Work Order ID 161706

DESIGN <i>CP</i>	DRAWN BY <i>CP</i>	DART AEROSPACE LTD HAWKESBURY, ONTARIO, CANADA	
CHECKED <i>#</i>	APPROVED <i>#</i>	DRAWING NO. D3016	REV. A SHEET 1 OF 3
DATE 01.05.18		TITLE SEAT FRAME ASSEMBLY	SCALE NTS
A	01.05.18	NEW ISSUE

DRAWING NO. D3016	TITLE SEAT FRAME ASSEMBLY	REV. A	DART AEROSPACE LTD ENGINEERING ORDER	D.E.O. NO. D3016-A-1	SHEET NO. SHEET 1 OF 1	SCALE NTS
DRAWN <i>1</i>	CHECKED <i>UP</i>	MFG. APPR. <i>RE</i>	APPROVED <i>MAP</i>	DE APPR. <i>TH</i>		
DATE 10.01.29	DATE 10.01.29	DATE 10.01.29	DATE 10.01.29	DATE 10.01.29	DATE 10.01.29

D3016-11 SADDLE

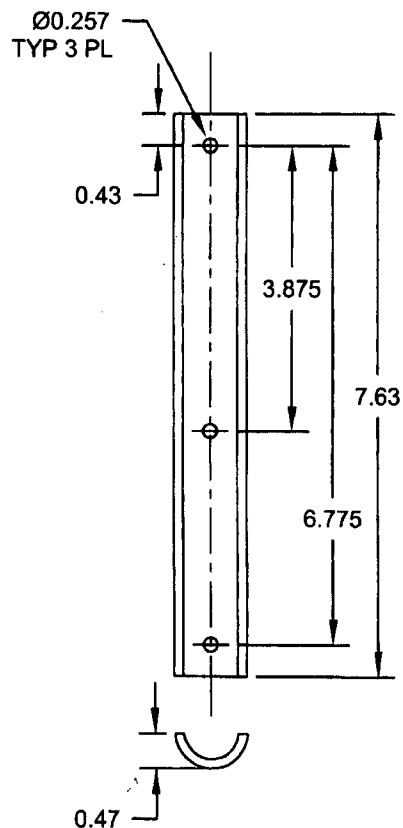
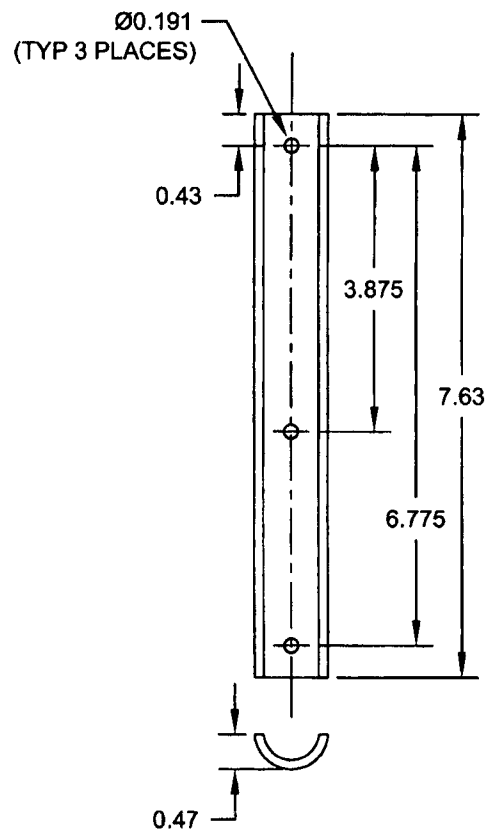
TO REVISE D3016-11 SADDLE'S HOLE SIZES

DETAIL D3016-11 SADDLE (SHEET 3): Ø0.257 TYP 3 PL WAS Ø0.191 (TYP 3 PLACES) AS SHOWN:

IS:
